RECALL 25V708 / 2025-568 REMEDY INSTRUCTIONS

FOREST RIVER	Make(s): SALEM & WIDLWOOD Model(s): SBT301FAM & WBT301FAM Model Year(s): 2026	Repair Code: RC-096-09-00-004763 Allotted Time: .25 HRS. Inspection Code: RC-096-05-00-004762 Allotted Time: .10 HRS.
	Concern: The exterior griddle may be stowed while still connected to LP Gas.	Photo(s) Required: NO Prior Authorization Required: YES Part(s) Kit Number: F100799572 Part(s) Return: NO, FIELD DESTROY

FIGURE 1:

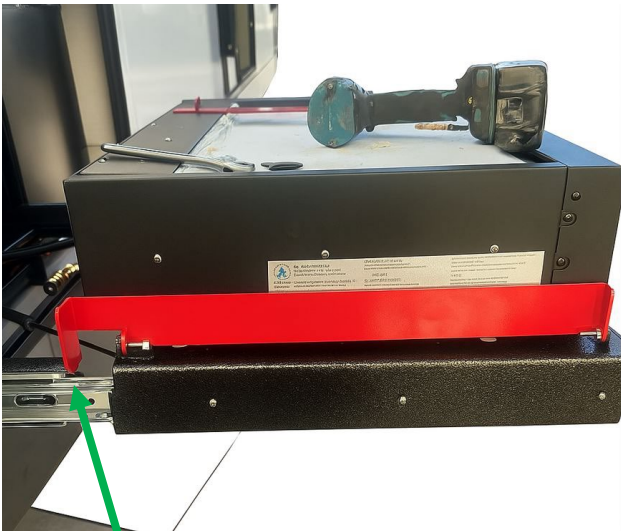
- IF THE RED LOCKING MECHANISM LOOKS LIKE FIGURE 1, CLAIM THE INSPECTION CODE;
- IF THE RED LOCKING MECHANISM LOOKS LIKE FIGURE 2, MOVE ON TO THE REMEDY;

CORRECT LOCKING BRACKET
NOTICE THE END - HAS LOCK

INCORRECT LOCKING BRACKET
NOTICE THE END - NO LOCK

STEP 1: DRILL OUT THE RIVET(S) OUT WITH A 3/16" DRILL BIT;

STEP 2: INSTALL THE REPLACEMENT RED LOCKING MECHANISM AS SHOWN IN FIGURE 1;

- USE THE INCLUDED BOLT(S) AND NUT(S);

STEP 3: ENSURE THE LOCKING MECHANISM PERFORMS AS INTENDED, NOT ALLOWING THE GRILL/GRIDDLE BE STOWED;
